LINO TYPE IMPROVEMENT SHEET

NO. 284

DISTRIBUTOR CLUTCH SHAFT (ASSEMBLED)

ADJUSTABLE DISTRIBUTOR SCREW CLUTCH SPRING

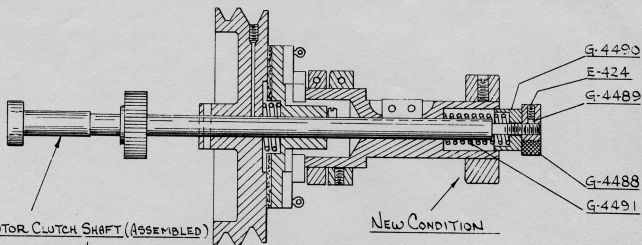
A change has been made on the Distributor Clutch which will permit adjustment of the pressure exerted by the Distributor Clutch Flange Spring in order to satisfy varying conditions prevalent in driving the Distributor.

Can be applied to all outstanding Machines by substituting the new Distributor Clutch Shaft (Assembled) and adding one each of E-424, G-4488, G-4489, G-4490, G-4491.

- G-4495 MODEL # 35
- G-4496 " # 29-30-36
- G-4497 " # 34
